STAFF REPORT  
KETCHUM PLANNING AND ZONING COMMISSION  
MEETING OF May 20, 2026

PROJECT: Wood River YMCA (Addition)

FILE NUMBER: P25-068A

APPLICATION: Design Review

COPYRIGHT © 2026  
DRAWING  
BUILDING ELEVATIONS - ENLARGED  
DWG #

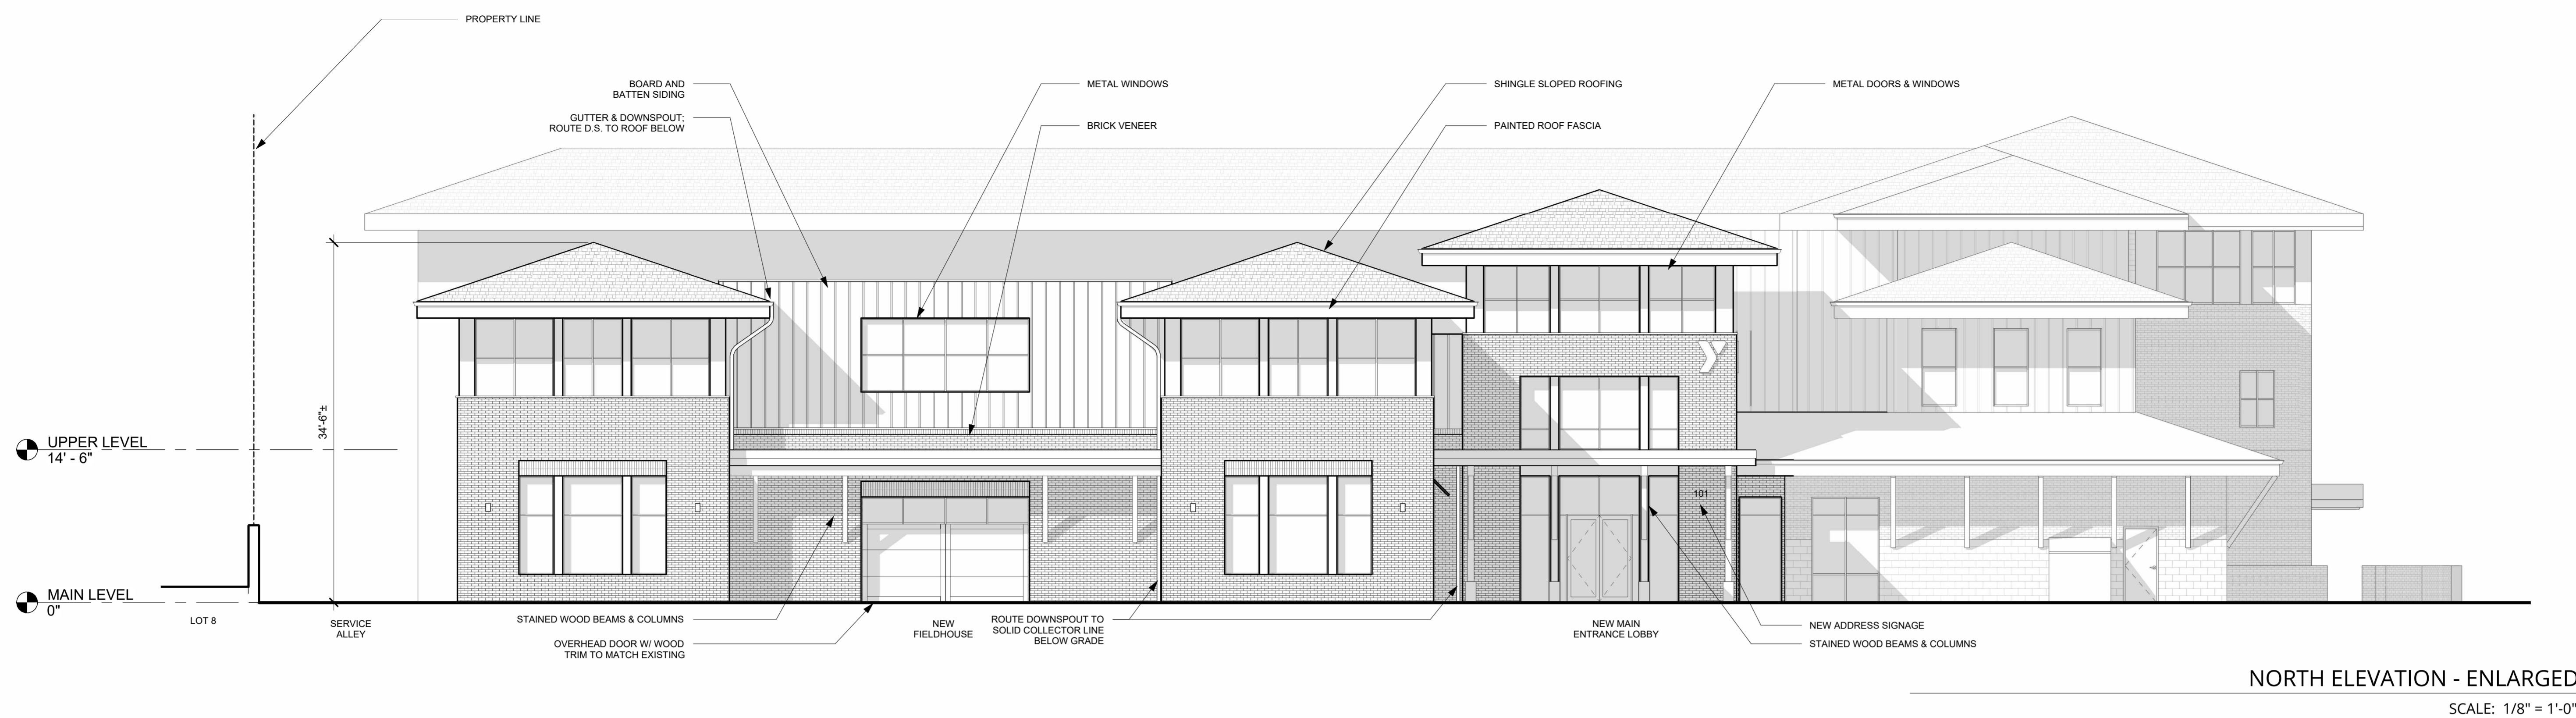
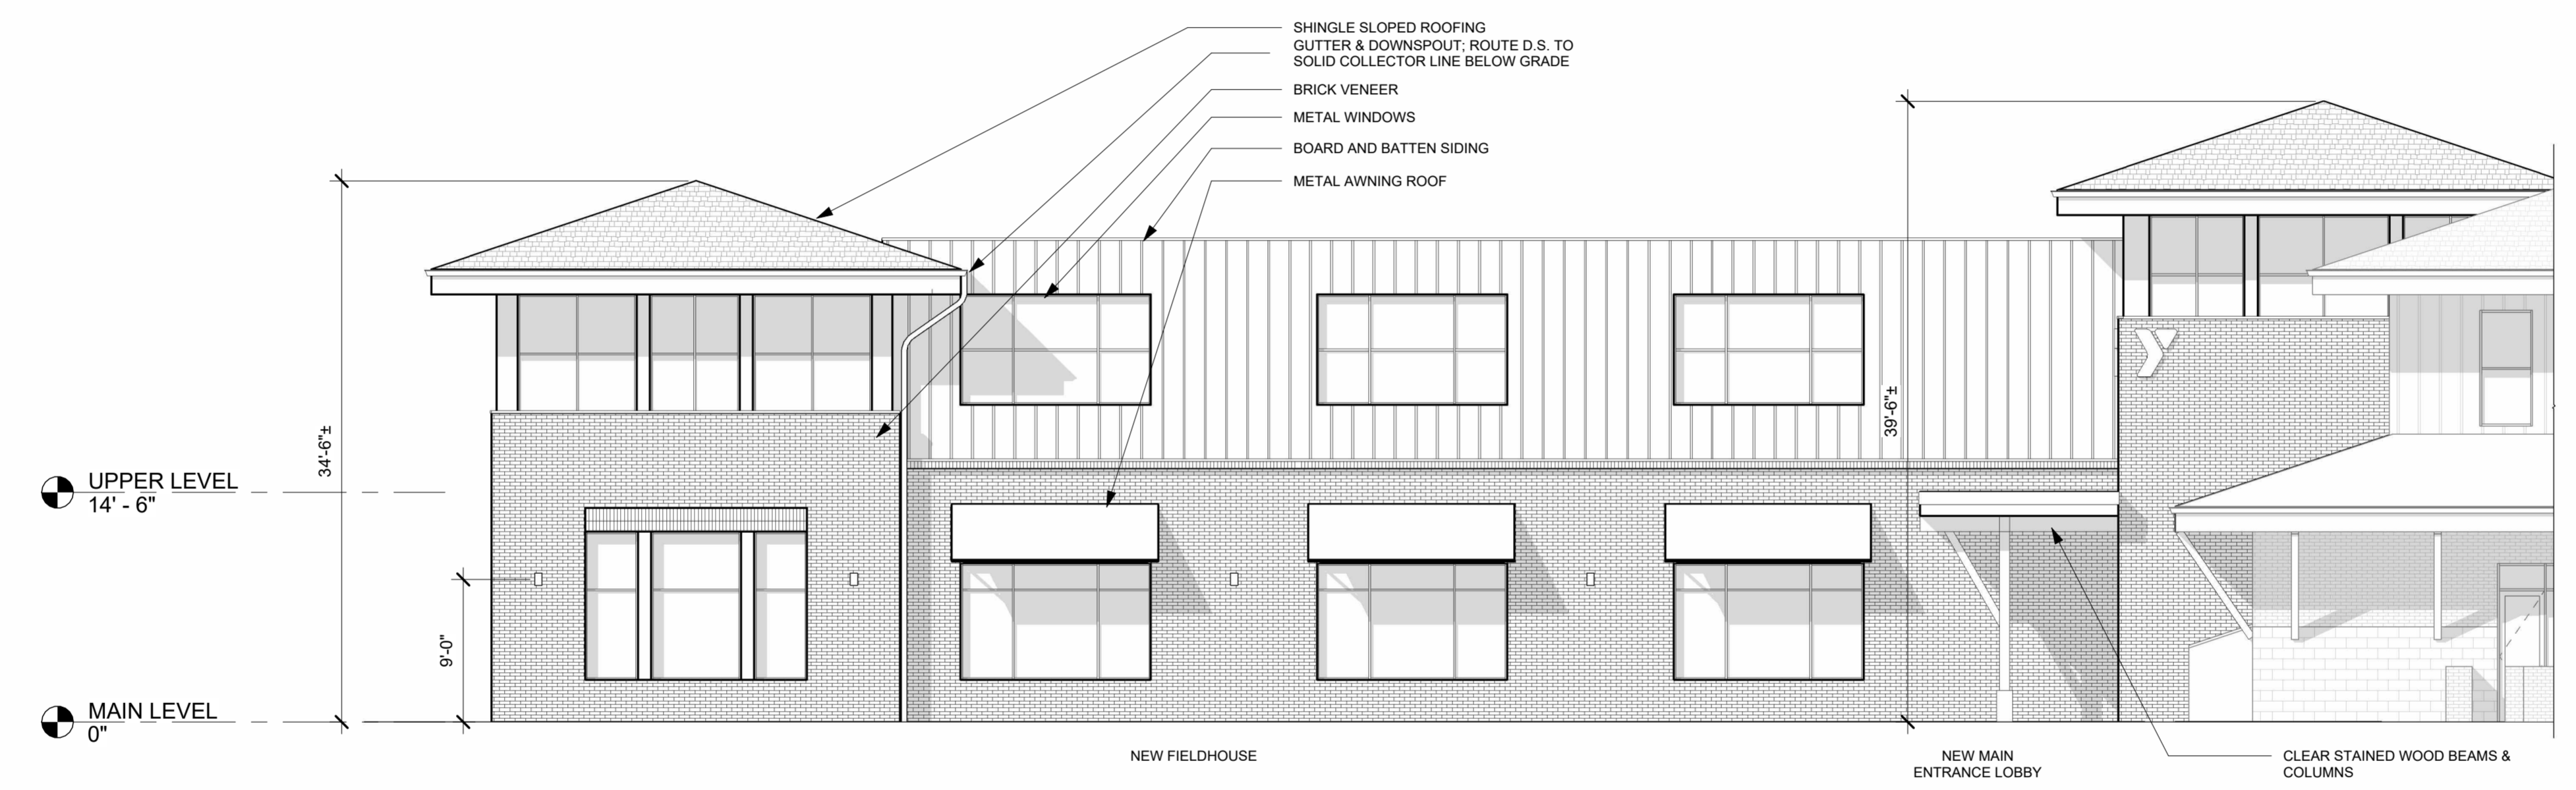
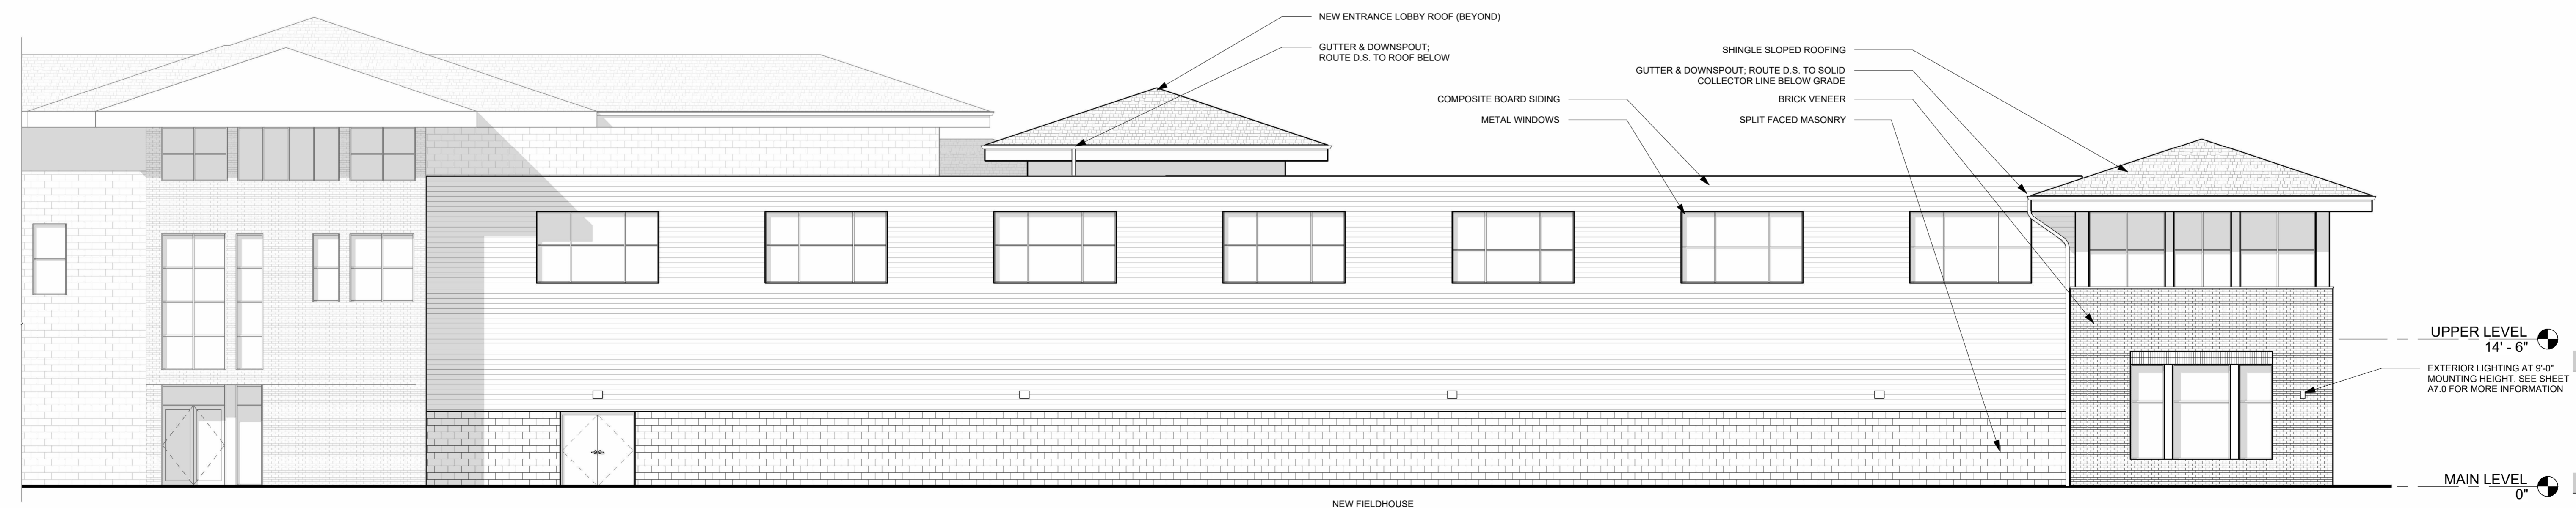
**Height-**The required building height per 2005 CUP-PUD is 45'6". Both proposed elevations are below the maximum height requirement.

Proposed elevations (Refer to Attachment B: Project Plans, Sheets A.4, A4.1):

- Northern addition of 34'7"
- West elevation lobby roof top 39'7"
